NOTICE OF PROPOSED AMENDMENT (NPA) No 04/2006

DRAFT DECISION OF THE EXECUTIVE DIRECTOR AMENDING DECISION NO. 2005/06/R OF THE EXECUTIVE DIRECTOR of 12 December 2005 on Certification Specifications for Large Aeroplanes (CS-25)

Symbolic Exit Signs And Revised Standards for Cargo Compartments (D To C)

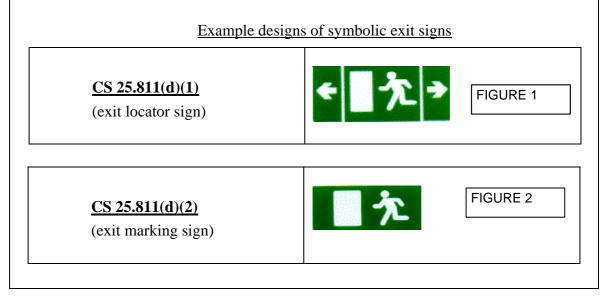
For the symbolic sign required by CS 25.811(d)(2) (See Figure 2), the height of the symbols should be at least 38mm (1.5 inches).

For the symbolic sign required by CS 25.811(d)(1) (See Figure 1) and for the symbolic sign required on each bulkhead or divider by CS 25.811(d)(3) (See Figure 3), the formula given in draft British Specification 5499 Part 4: "Code of practice for escape route signing", applies. The formula is as follows:

The maximum viewing distance "D" to be considered should be the maximum distance found between two adjacent exits on one side. If the minimum height calculated for the symbols is less than 38mm (1.5 inches), 38 mm (1.5 inches) should be taken.
